SIGAR 17-03 Inspection Report

Special Mission Wing Facilities at Kandahar Airfield: Construction Generally Met Contract Requirements, but Problems with Noncompliance, Maintenance, and Quality Assurance Need to be Addressed

This is the U.S. Army Corps of Engineers (USACE) Transatlantic Division's (TAD) response to the SIGAR Draft Report I-035, "Special Mission Wing Facilities at Kandahar Airfield: Construction Generally Met Contract Requirements, but Instances of Noncompliance with the Contract and Quality Assurance Procedures Need to be Addressed" dated August 2, 2016.

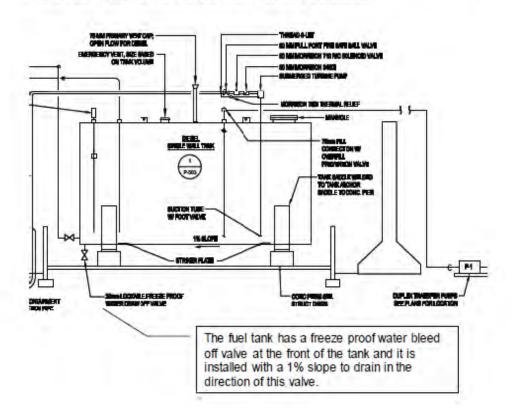
c. Install the water draw off lines in the power generation plant. Non-Concur. The contractor properly constructed the power generation plant in accordance with contract drawings and specifications. The 100% design drawings, shown below, for the fuel tanks, indicate the location of the installed water draw lines. The fuel tank is equipped with a freeze proof water bleed off valve that is found at the front of the tank. The tank is installed with a 1% slope to allow for draining in the direction of the valve. Section 01015, Para. 5.17.1, which is specific language for the power plant generators, has no reference to UFC 3-460-01. It is doubtful whether any of the provisions of UFC 3-460-01 are applicable since they are not specifically referenced.
